10629 Versailles- Tract 3 Septic revision

10629 Versailles Rd
M 146 P 054.00
Lot 3

Lot 3

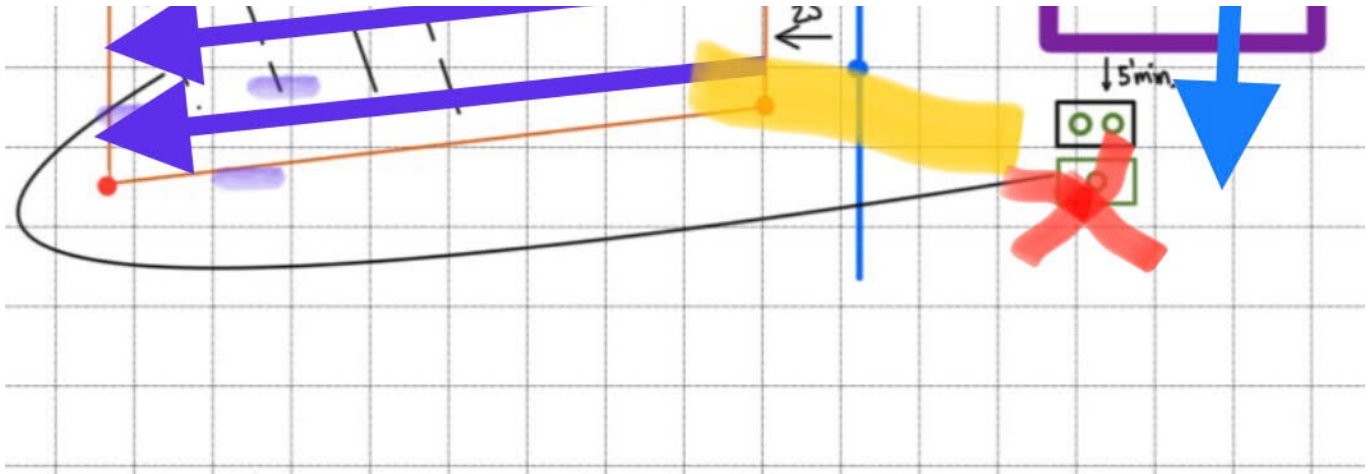
This follows the contour better according to installer. The yellow portions are hard pipe. Installer says tank outlet height is 24" higher than field line so pump tank deletion is requested. Thoughts?

Hard pipe

Delete pump
Tank b/c 24"
Fall per 100 ft

That looks fine. This email allows you to go ahead as requested. The final inspection will reflect the changes.
